OLDHAM ROAD

NON-MATERIAL AMENDMENT REPORT

D464-TGA-RP-FI_90_72-0001

31.03.23

1.0 WINDOW DISTRIBUTION

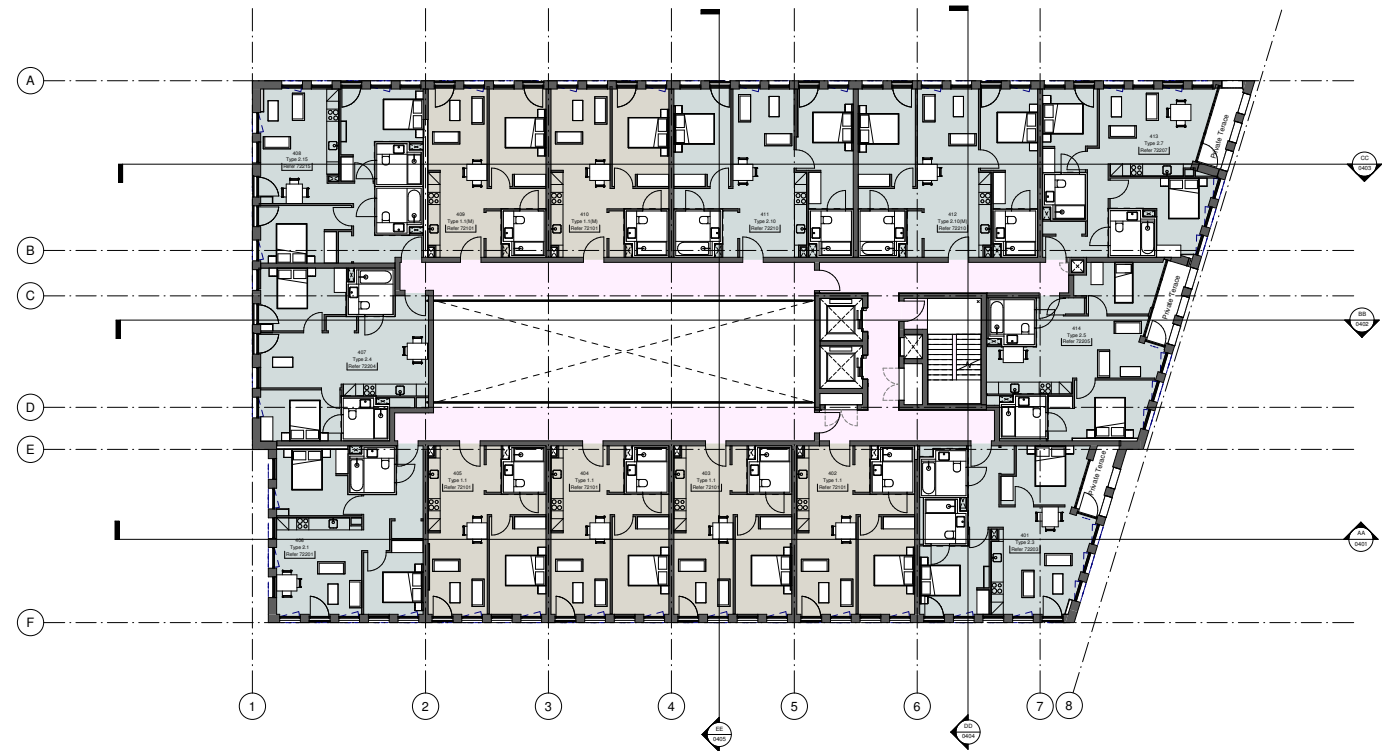
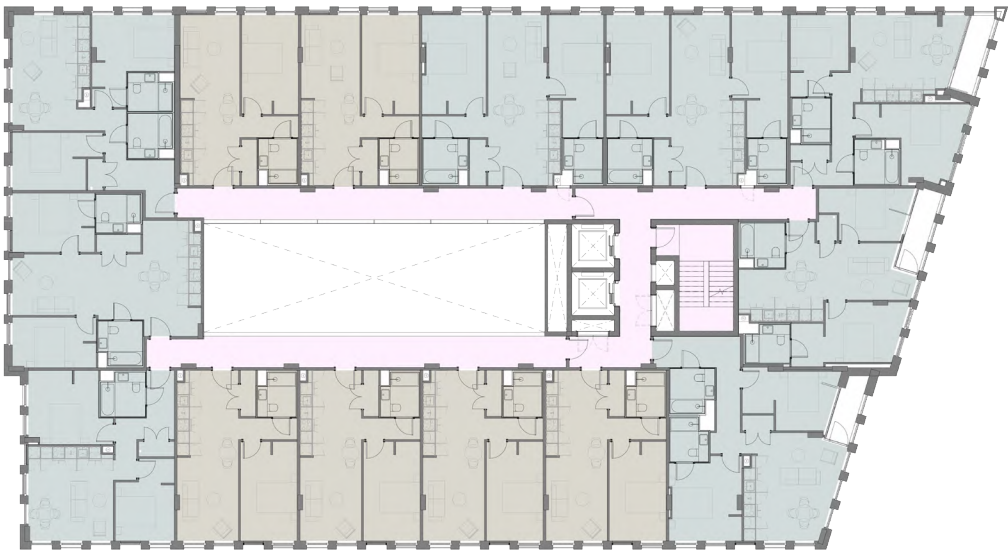
The original strategy for windows in the apartments included a mix of juliet balconies, windows on fixed restrictors, fixed pane windows and spandrel panel windows.

Through design development, juliet balconies were added in place of windows on restrictors to provide improved amenity for the residents.

The mix of juliet balconies, fixed pane windows and spandrel panels were then redistributed across the facade to retain a balanced elevation and proportion of openings within the apartments for daylighting and overheating purposes.

2.0 PLANT LAYOUT

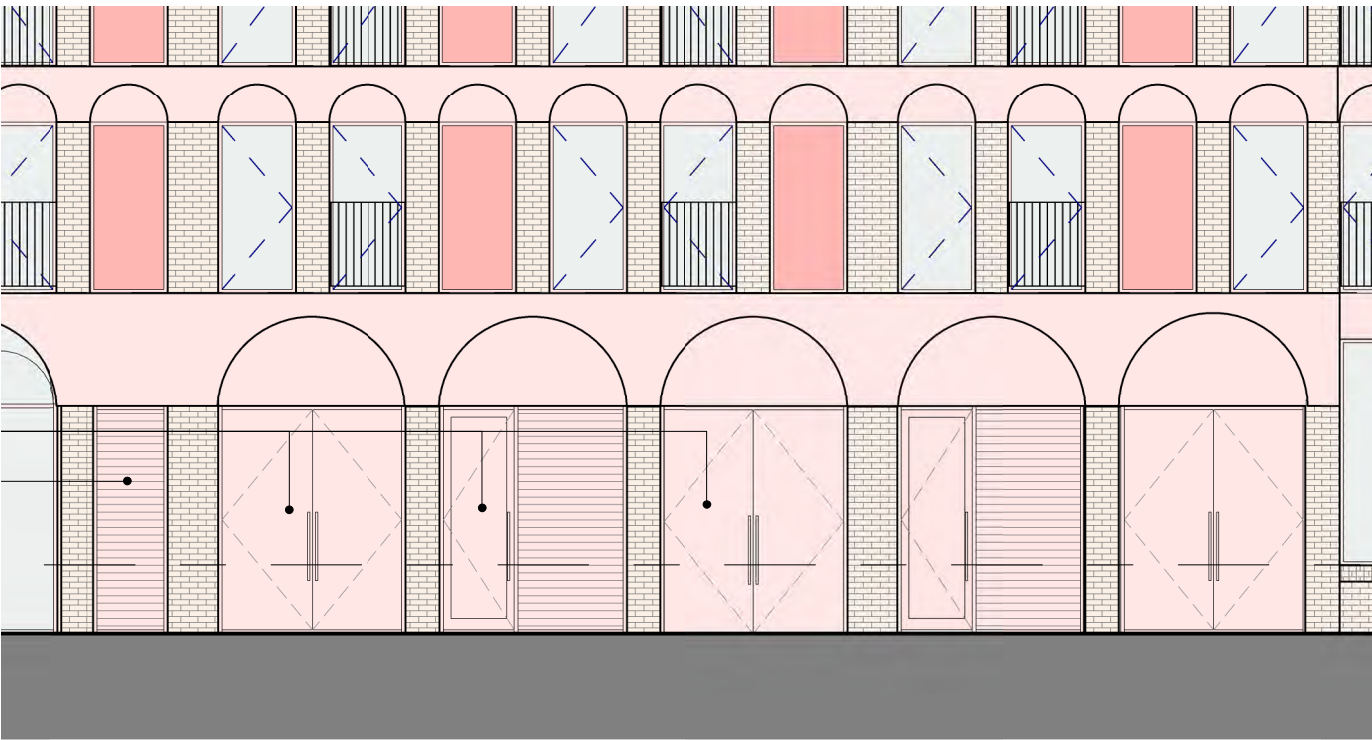
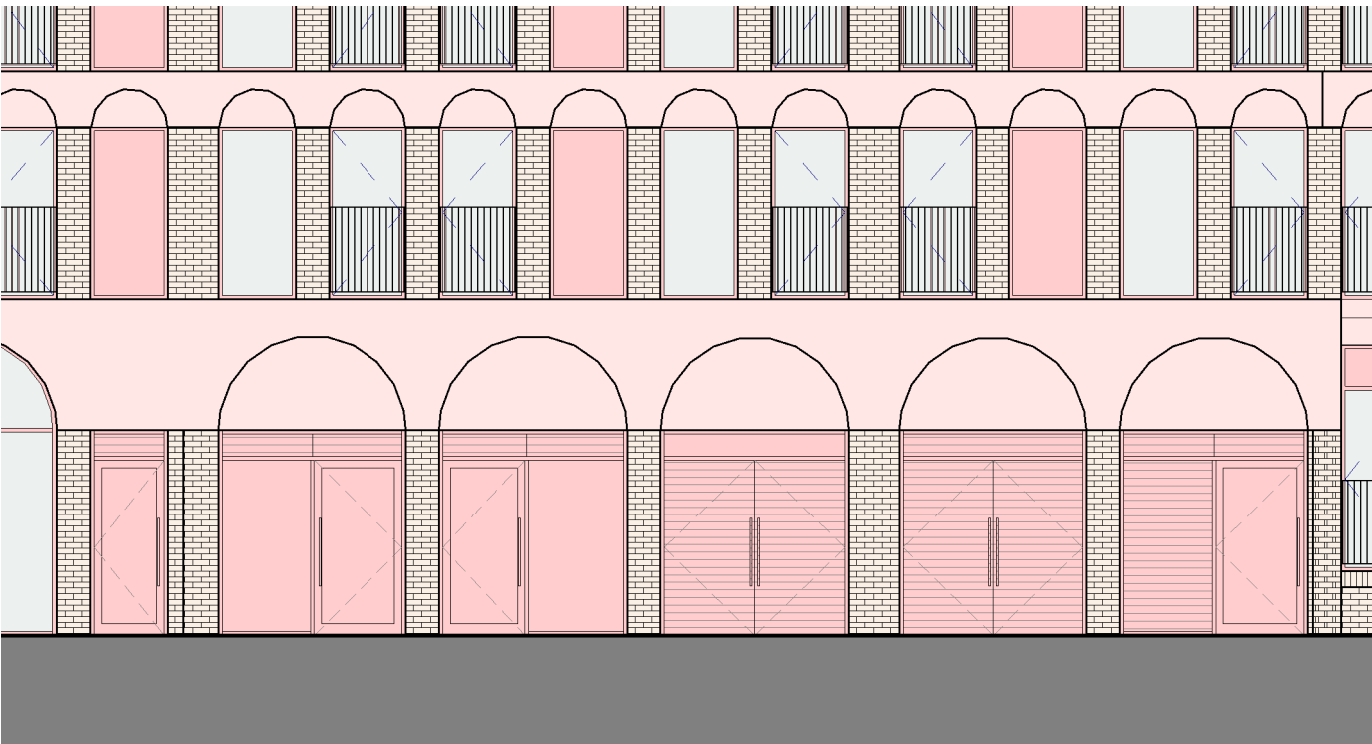
Plant room layout and associated back of house access and ventilation strategy developed at detailed design.

This requires a minor rearrangement of doors and louvred panels within the proposed curtain walls.

SECTION - ATRIUM & SMOKE VENT SHAFT

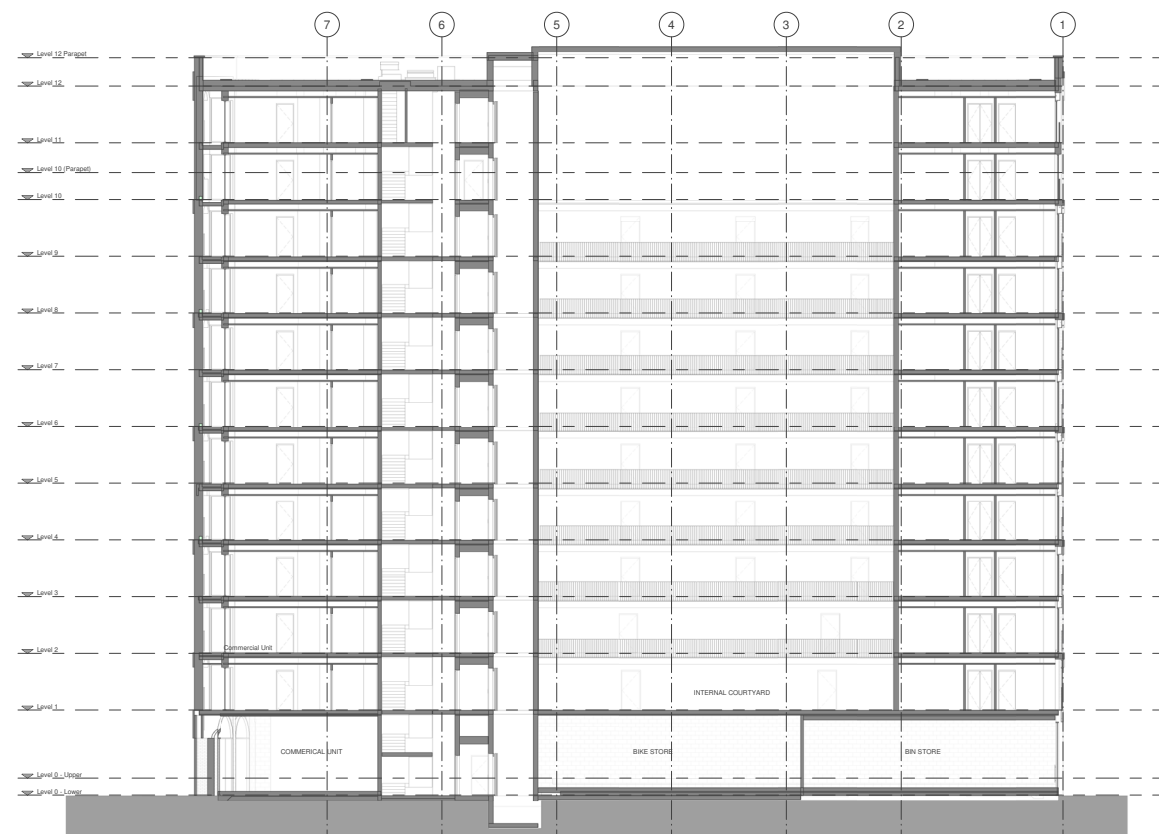
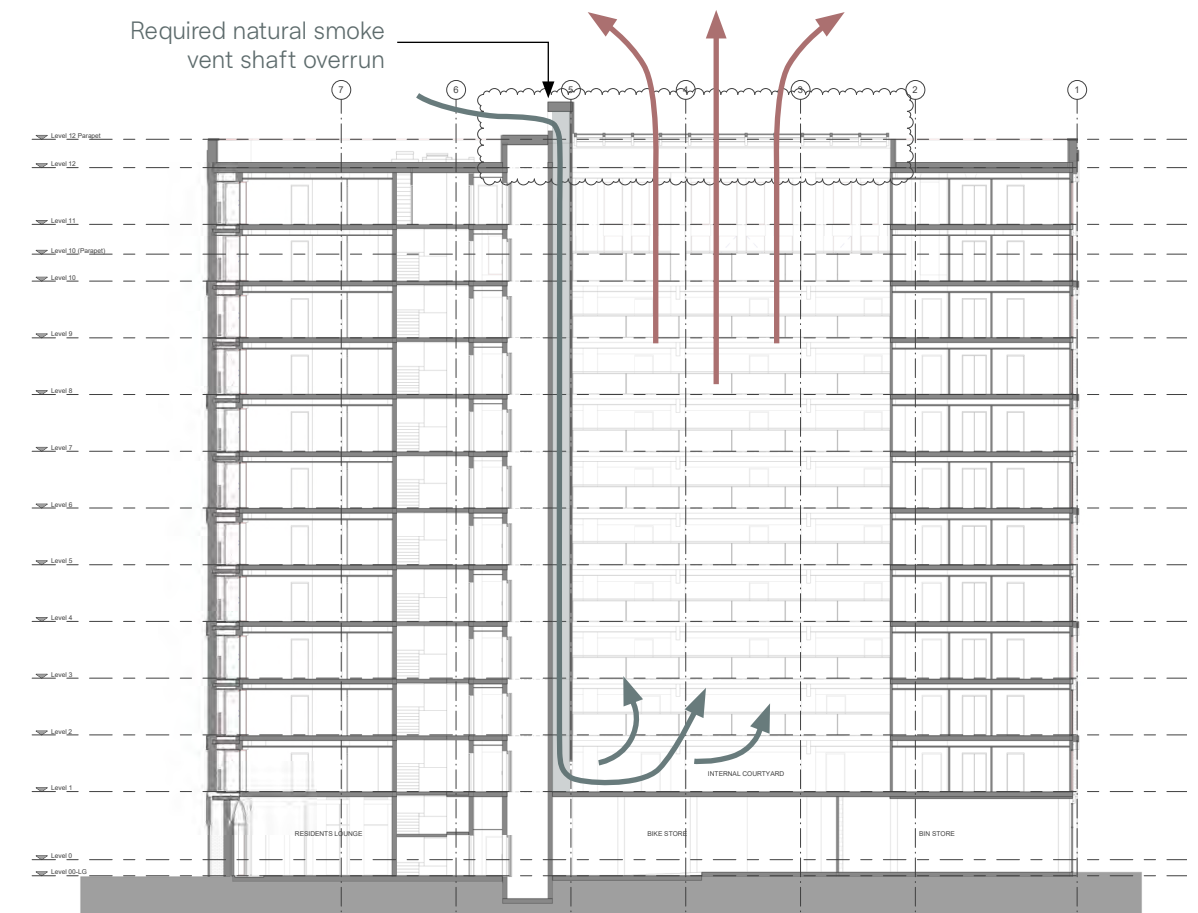
Through detailed development of the building Fire Strategy using Computational Flow Dynamic modelling, an air inlet shaft has been added to provide intake air to the atrium and circulation routes, in the event of fire.

The proposed shaft sits next to the lift core and is required to take fresh air 5m away from the opening of the rooflight via ductwork.

View from Oldham Road / Great Ancoats Street

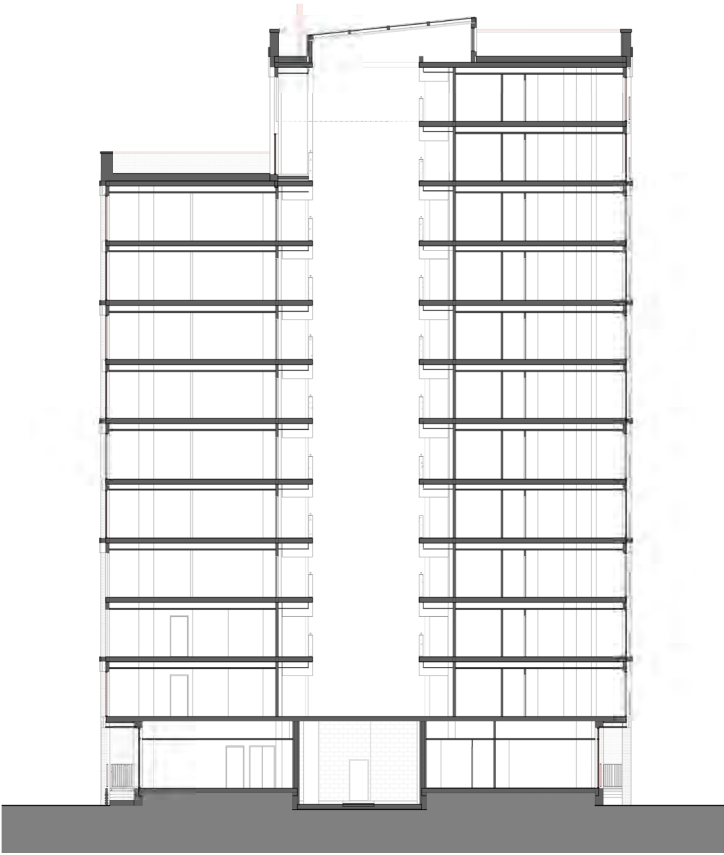
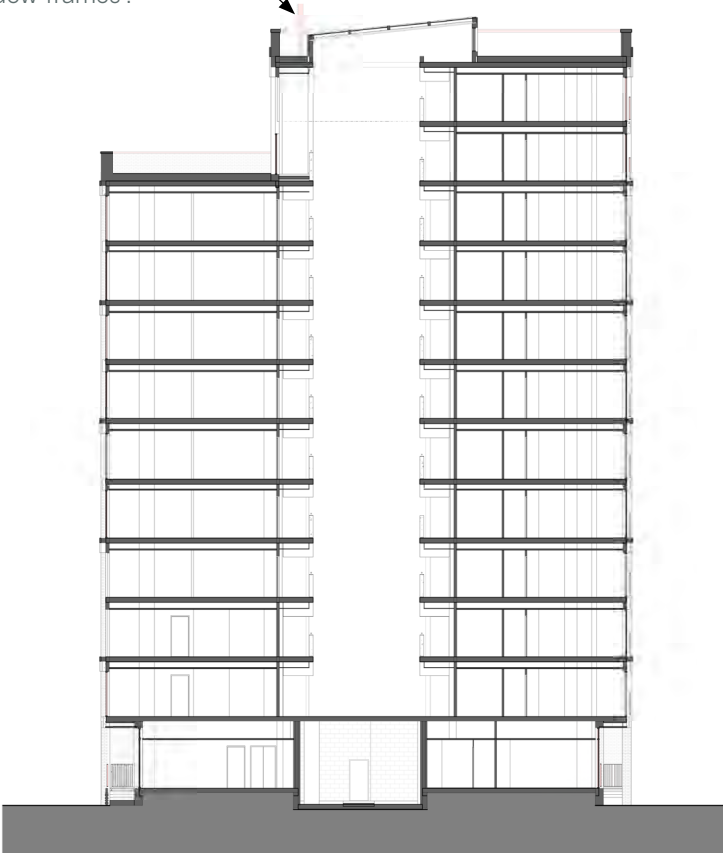
The plant and shaft described in section 3. underwent detailed discussions with Manchester City Council. To mitigate the visual impact of these elements, a metal louvred screen is proposed to the roof top on Addington Street elevation. This has been designed to suit the massing and proportion of the building, and is polyester powder coated to the same colour and finish as all other metal work on the building facade.

Louvred plant screen colour matched to window frames.

4.0 SPANDREL BLANKING PANELS

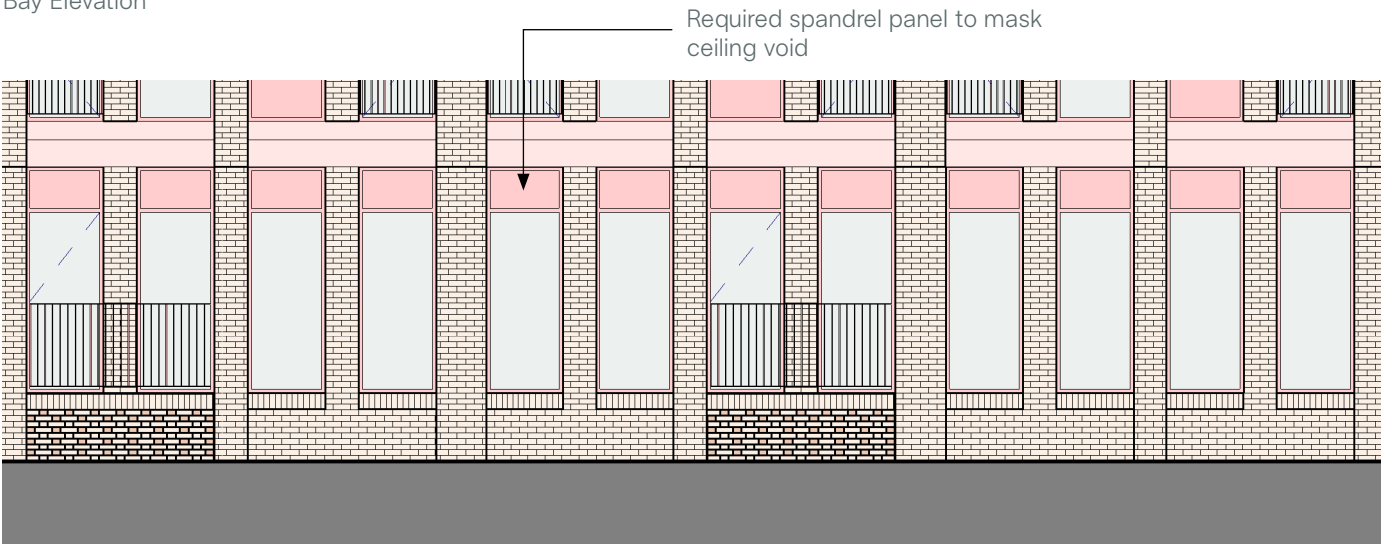
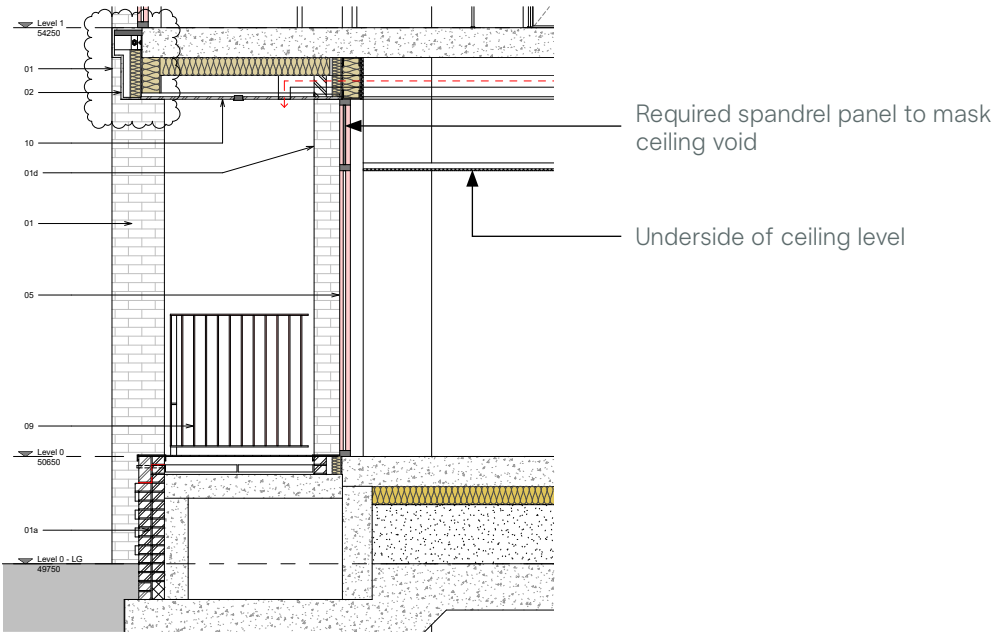
Spandrel panels introduced to ground floor windows to conceal ceiling voids, as illustrated in the below bay elevations and section.

ELEVATION - CHADDERTON STREET

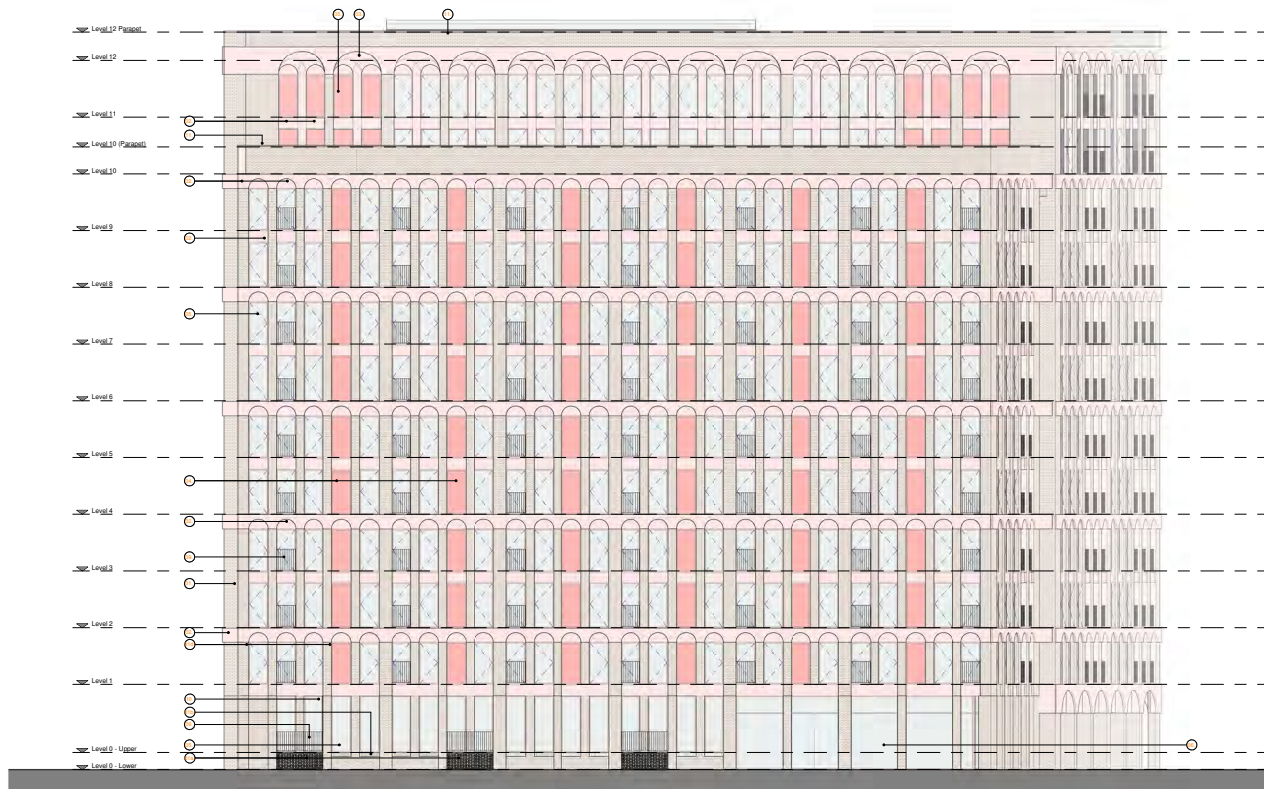
Through design development, 11no GRC panels located at street level on Chadderton St have been changed to brickwork, retaining the concept of the pier design. It was deemed that the GRC at street level may be vulnerable to graffiti and that brickwork would be better maintained in this location.

ELEVATIONS - ADDINGTON STREET

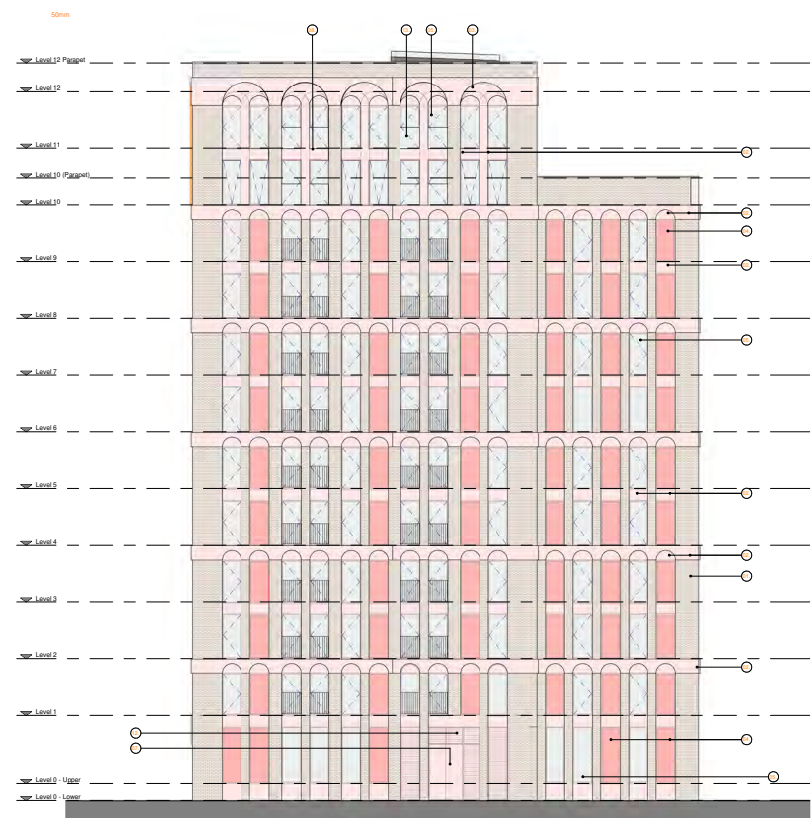
Proposed alterations to Addington Street elevation;

- Restricted opening windows to be replaced with juliet balconies for improved amenity
- Windows, juliet balconies and spandrel panels to be redistributed across the facade
- Spandrel panels to be introduced to ground floor windows to mask ceiling voids
- Skylight and associated smoke vent developed at detailed design
